SERVICE BULLETIN

N° **139-675**

ATA 97 - KIT CABIN CAMERA SOFT LINER INSTALLATION

Rev. A of this Service Bulletin is issued in order to extend the effectivity.

Figure 12

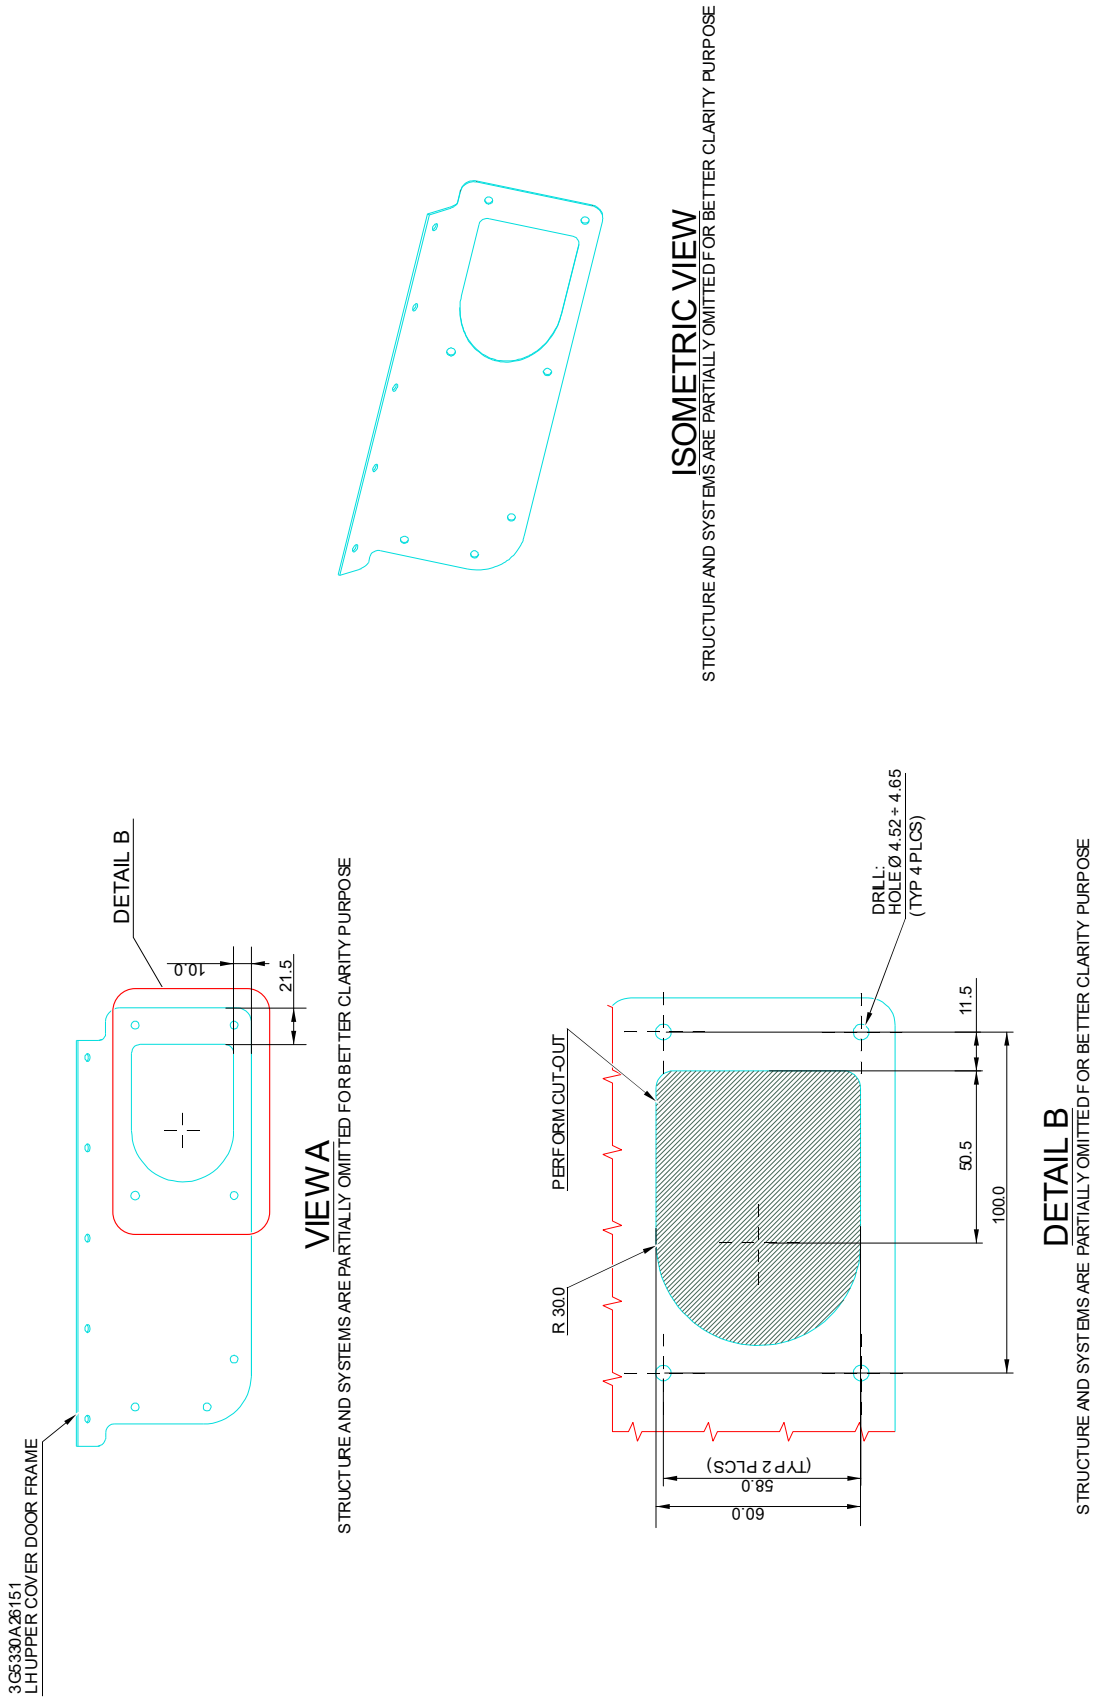
Furthermore, Rev. A includes new Fig. 12 in order to allow the rework of the upper cover door frame.

If it is supplied Productive P/N 3G9750A02531A2 instead of P/N 3G9750A02531, it is necessary to rework P/N 3G5330A26151 in accordance to Fig. 12 and install it with the P/N 3G9750A02531A2.

If it is supplied Productive P/N 3G9750A02531A2 instead of P/N 3G9750A02531, it is necessary to rework P/N 3G5330A26151 in accordance to Fig. 12 and install it with the P/N 3G9750A02531A2.
